TT7399EN
October, 2013
Page 1 of 7

SUBJECT: Transmission Control Module (TCM) Recalibration for Kenworth

MODELS AFFECTED: Kenworth T800, W900, and C500 models built between 1/25/13 - 07/15/13 and equipped Allison 4000 Series Product Family Transmissions and ISX Family 1 engines.

Table 1. Kenworth Chassis Numbers

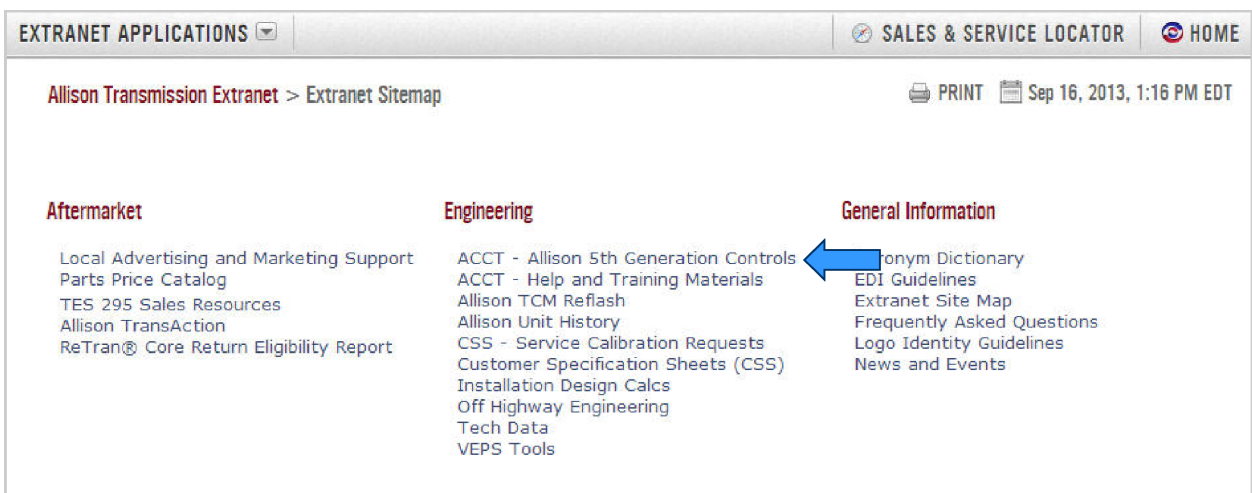
Kenworth manufacturing specified the incorrect torque converter type used with 5th Generation Controls transmissions and ISX Family 1 engines. Consequently, transmissions and calibrations were installed that contain either a TC541 or TC551 torque converter instead of the required TC561 configuration. Kenworth TIB 27-002 instructs Kenworth dealers to contact Allison Transmission distributors/dealers to replace the currently installed torque converter pump element with P/N 29514713; thereby converting the torque converter to a TC561 configuration.

394083	T800	6610368453	E017578	G019084	21-928	TC541	E017544	G020240	21-926	TC561
394294	T800	6610369821	E018264	G019277	21-927	TC551	E018356	G019789	21-926	TC561
396282	T800	6610368081	E017581	G018837	21-927	TC551	E017481	G018816	21-926	TC561
396443	T800	6610367742	E017581	G018837	21-927	TC551	E017481	G018816	21-926	TC561
397331	T800	6610368857	E017581	G018837	21-927	TC551	E017481	G018816	21-926	TC561
401853	T800	6610375421	E017481	G018816	21-926	TC561	No torque converter parts change necessary. Confirm TC561 in TCM calibration.

Engine torque management features require that the torque converter type is properly set in the TCM calibration; therefore, a calibration update is required. A new calibration must be reflashed into the TCM with the torque converter type set to TC561.
